# McLaren 720S and 765LT – Clutch Cooler Hose Clash Rework

**Bulletin type:** Service Campaign Bulletin  
**Reference number:** SCB14 L 003 (V2)  
**Attention:** Retailer Service Managers and Retailer Technicians  
**Affected vehicles:** 720S Coupe and Spider, 765LT Coupe  
**Situation:** Potential for insufficient gap tolerance between components  
**Procedure:** To action affected vehicles during next Retailer visit. Please refer to the information outlined in this document to ensure required gap tolerance is achieved  
**Date:** 21<sup>st</sup> January 2021

Example: Clip assembly installed with min. clearance tolerance to achieve

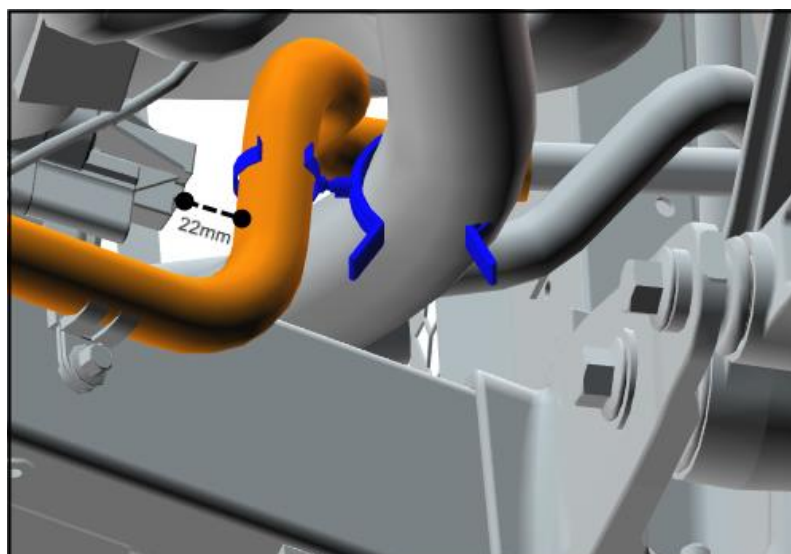
Through continuous product quality monitoring, it has been identified that a number of McLaren 720S vehicles (Coupe and Spider versions) and 765LT Coupe, may have an insufficient gap tolerance between the Clutch Cooler Hose and the Turbocharger Wastegate. This could cause damage to the components; therefore, a preventive rework solution has been released.

- Check the part number of the installed Clutch Cooler Hose and replace if necessary (if a P13 part is installed, replace hose)
- Install a double 'C' clip which will increase the gap tolerance

**CARE POINT:** If the required gap tolerance still cannot be met, replace the Clutch Cooler Hose. Do not adjust the hose position at the front hose clamp end as the required tension will not be met.
